P 518 515
 A 56600-T

~~INDEXED~~
ON-SITE SEWAGE DISPOSAL SYSTEM
HOWARD COUNTY HEALTH DEPARTMENT
BUREAU OF ENVIRONMENTAL HEALTH
NO # bond

Fogles Septic Clean, Inc IS PERMITTED TO INSTALL ALTER
 ADDRESS: 580 Obrecht Road, Sykesville PHONE NUMBER: 410-795-5670
 SUBDIVISION: High Forest Estates LOT NUMBER: 20
 ADDRESS: 15165 Sapling Ridge Drive PROPERTY OWNER: Big Branch Overlook
 SEPTIC TANK CAPACITY (GALLONS): 1500 * OUTLET BAFFLE FILTER REQUIRED *
COMPARTMENTED TANK W/ MANHOLE ACCESS REQUIRED *
 PUMP CHAMBER CAPACITY (GALLONS): 1500 ** COMPARTMENTED TANK REQUIRED
WITH MANHOLE ACCESS **
 NUMBER OF BEDROOMS: 4
 SQUARE FEET PER BEDROOM: 180
 LINEAR FEET OF TRENCH REQUIRED: 240

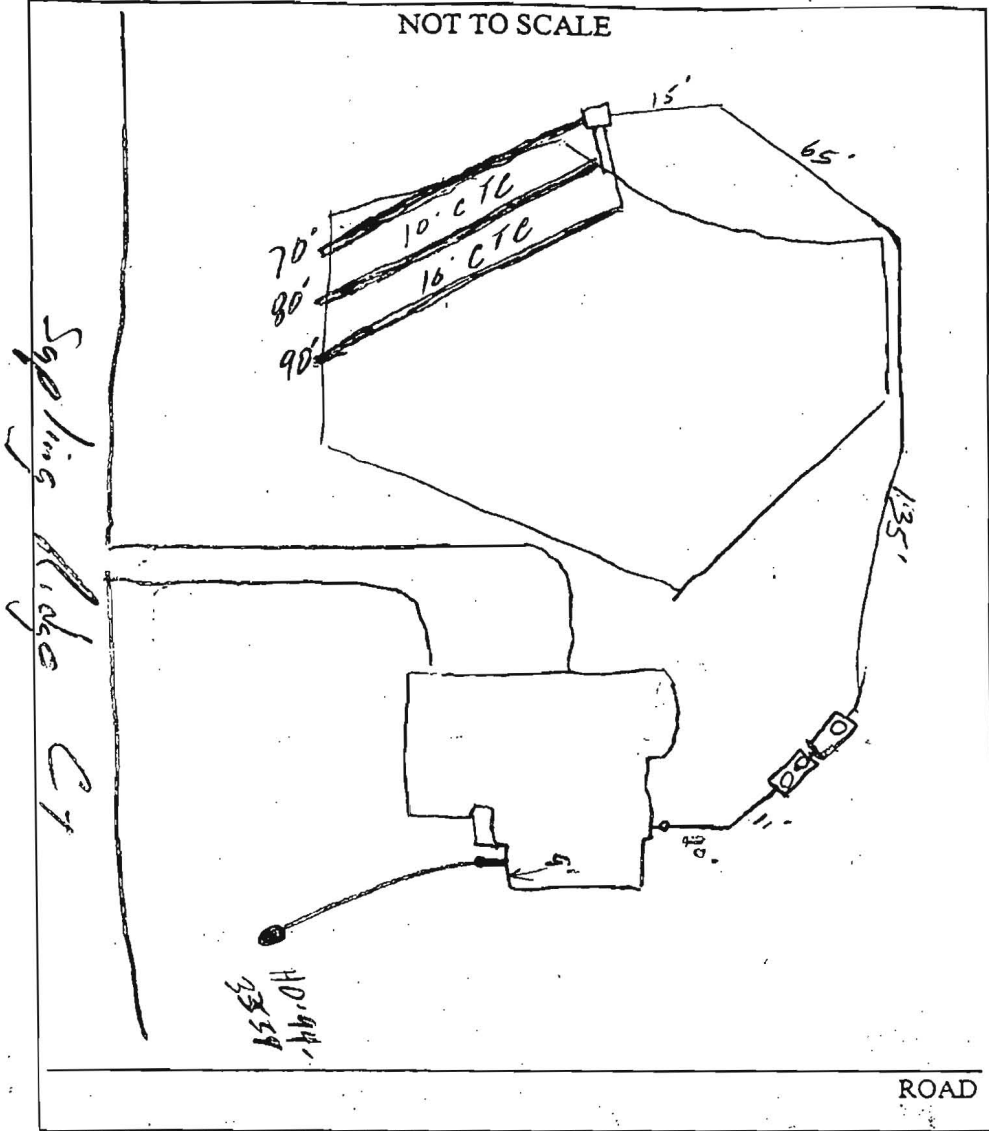
PRE-CONSTRUCTION 1/23/03 Lot staked, contour a little off, place D.B. closer towards Oak Ridge while maintaining 100' well radius. (SD)

INSTALLATION 2/5/03 - Tanks set, 3 trenches installed. OK to cover. (SD) 2/6/03 ground around tanks needs to be cut down. OK to cover all work. Pump & Alarm tests needed. (SD)

4/25/03 Pump & Alarm test OK (SD)
